RE: Comments made by Greg Kulma and Kevin C. Garrahan on the
Hydrogeologic and Extent of Contamination Study for Chem-
ical Recovery Systems

SUBJECT: Review Comments Chemical Recovery Systems, Inc.
Hydrogeologic and Extent of Contamination Study

SUBJECT: Peer Review of E & E Hydrogeological Study of Chemical
Recovery Systems - Elyria, Ohio

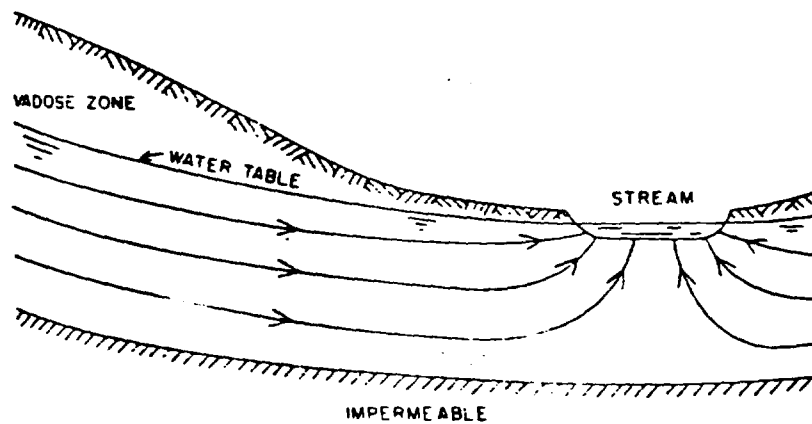
- 16 Calculations for groundwater flow are based on an assigned permeability value and the river depth of eight feet. The river depth should not be used to calculate the cross-section area normal to the flow since the flow lines converge to the sides and bottom of the stream (see sketch below).

Since the characteristics of the underlying sandstone aquifer are not known, then perhaps it would be best to calculate the flow of groundwater through the layer of unconsolidated fill. In this case, the maximum thickness of fill (28 feet) would be used in Darcy's Equation. Computation of the equation would yield the maximum flow of contaminated groundwater through the site.

Pertaining to his comments on using the entire stream bottom as the area perpendicular to flow, in the flow rate calculation:

- 1) The example figure he gives does not resemble the conditions at the site.
- 2) The Black River is not the major discharge area for groundwater.
- 3) Besides these facts, the thickness that would be used to calculate the flow rate through the fill would be the saturated thickness not the maximum thickness of fill (28 feet).
